Subject: AP1000 Response to Request for Additional Information (SRP14.3.2)

AP1000 TECHNICAL REPORT REVIEW

RAI Response Number: RAI-SRP14.3.2-CCIB-01

Figure 1 – Water Level Specifications

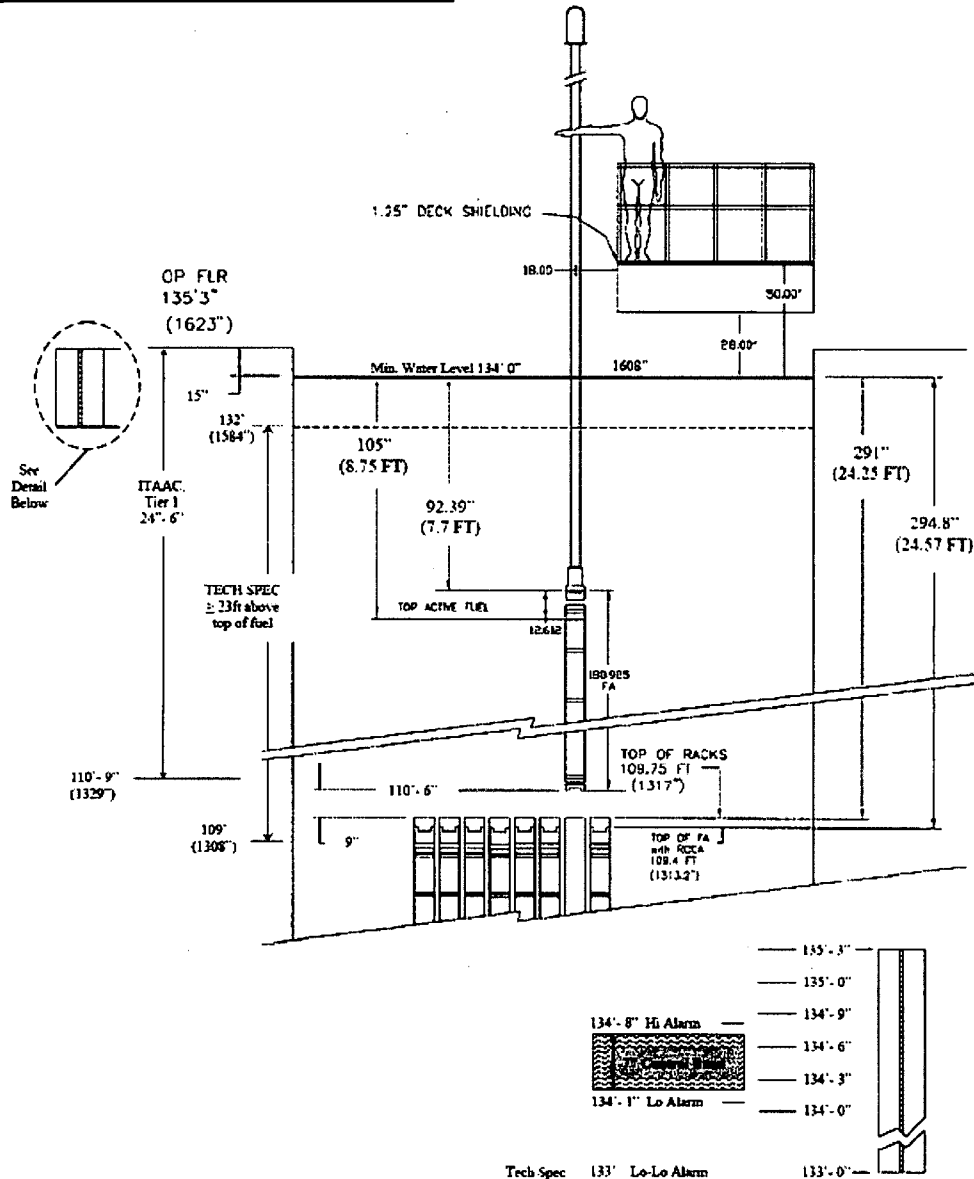
In Table 2.1.1-1, Item 5, the design commitment states the following: "The lift height of the Refueling Machine (RM) and Fuel Handling Machine (FHM) masts is limited such that the minimum required depth of water shielding is maintained." The minimum required depth of water shielding is specified in the Tier 2 Sections 9.1.2.2, 9.1.4.2.3, and 9.1.4.3.7 and Westinghouse Technical Report 121 (APP-GW-GLN-121) as 9.5 feet above the top of a fuel assembly.

The schematic, Attachment 3, provided in TR-121 shows that 24.8 feet of water is required above the top of the irradiated fuel assemblies seated in the spent fuel storage racks to move irradiated spent fuel assemblies and requires a minimum depth of water shielding of 9.5 feet above the top of active fuel in a fuel assembly being moved. Assuming the same operating deck elevation and water level for the reactor refueling cavity as the spent fuel pool, 24.5 feet of water is required above the top of the reactor vessel flange to provide the minimum depth of water shielding of 9.5 feet for spent fuel movement. However, technical specification sections 3.7.5 and 3.9.4, respectively, require the SFP water level to be greater than or equal to 23 feet over the top of irradiated fuel assemblies seated in the storage racks and the refueling cavity water level to be greater than or equal to 23 feet above the top of the reactor vessel flange for spent fuel movement.

The ITAAC in Table 2.1.1-1, Item 5 appears to be in disagreement with the technical specifications stated above. Explain the apparent discrepancy between what is required in the acceptance criteria for Item 5 and the 23 feet that is required in the technical specifications stated above.

The sections of the DCD which specify the minimum height above the fuel to be 9.5 feet when fuel is being moved was updated in Rev. 17 to reflect an approved change to 8.75 feet. The current analysis shows that if 8.75 feet of water is maintained above the top of active fuel, dose rates are at or below 2.5 mRem per hour.

The current design of the Spent Fuel Pool design requires 23 feet above the active fuel in its stored position, which is given in tech specs. There are three safety related sensors available to signal when the minimum of 23 feet above the active fuel has been exceeded.

With the pool at its minimum normal elevation (134'-0") the distance between the top of the moving fuel and the surface of the water is maintained at the 8.75 feet value. Also, if the fuel is

being moved at the minimum normal water level (134' 0"), there are 9 inches of clearance between the bottom of the fuel and the top of the racks to ensure an acceptable amount of clearance. Figure 1 reflects the current design.
